Appeal of Planning Commission Resolution No. 26-05 Regarding Coastal Development Permit No. 19-012 (25200 Pacific Coast Highway, APNs 4459-013-021 and 4459-014-018; Owner, PAR PCH, LLC; Appellant, Jun Hall for Concerned Citizens of Malibu Road, Inc.)

Malibu City Council
Special Meeting Agenda

Wednesday, August 19, 2026

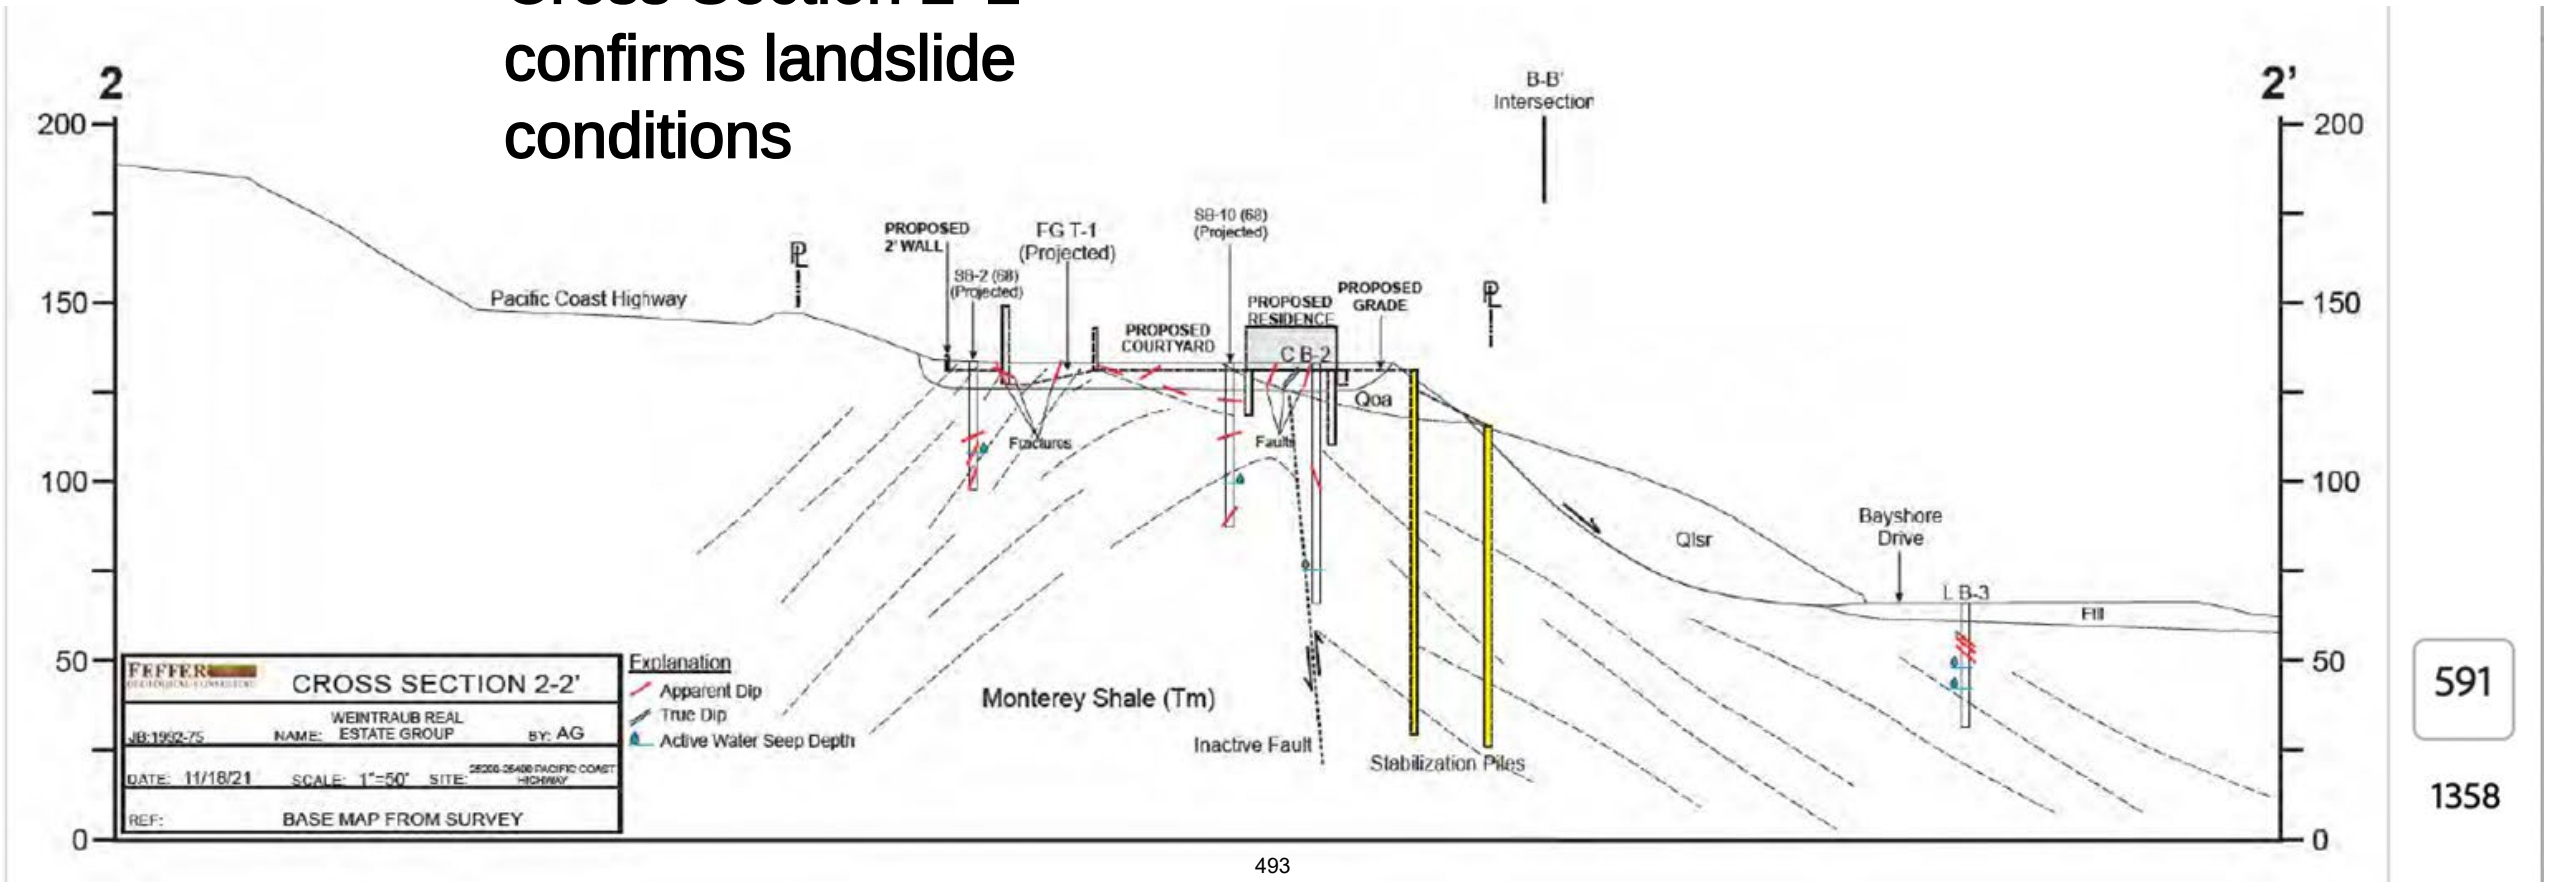
Very FAR OFF the required 1.5 static factor of safety

- Required minimum (LIP §9.4(D)): **1.5 static**
- Calculated results: **1.076 - 1.234**
- Values near **1.0 = marginal equilibrium / instability**

Pile Base Elevation vs Slide Base Elevation

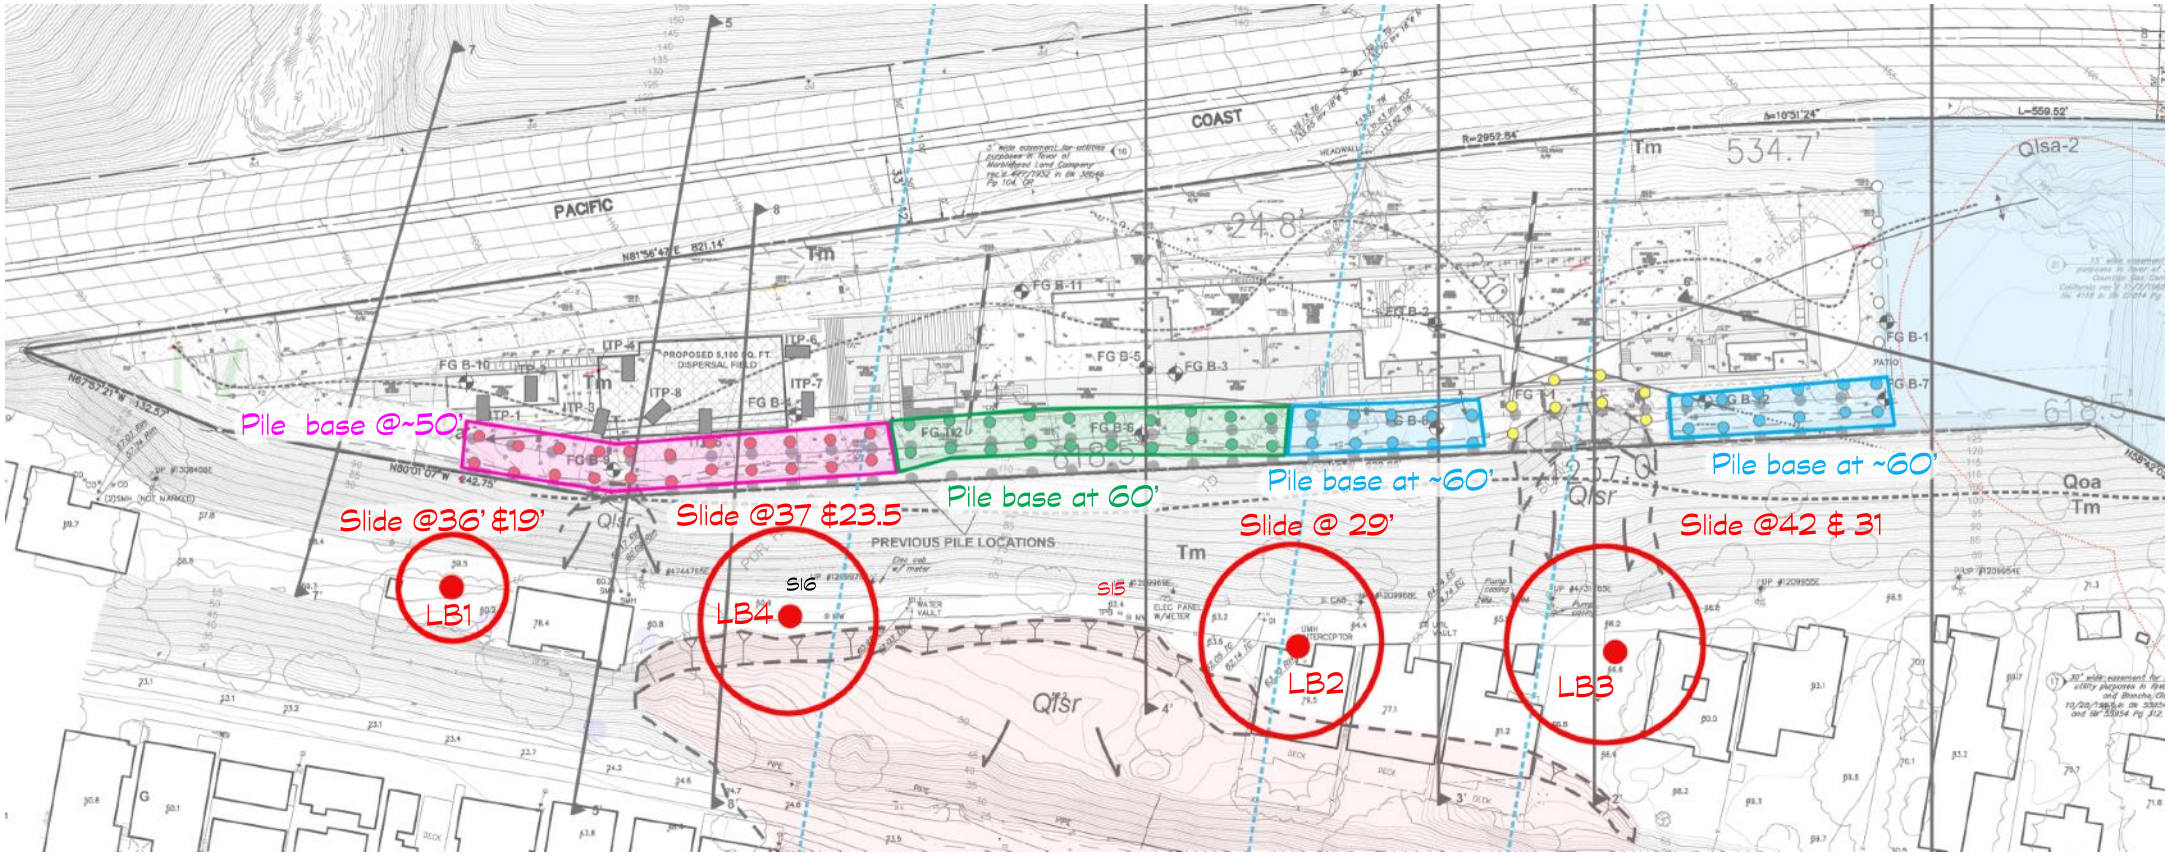
Pile color from map	Red	Green	Blue and Yellow
Depth/pile length	50’	60’	60’
Bottom elevation of pile	50’	60’	60’
Slide Plane Elevation	36’& 19’/37’23.5	37’-29’	29’-31’
Deficit	14’ to 31’	36.5’-31’	31’-29’
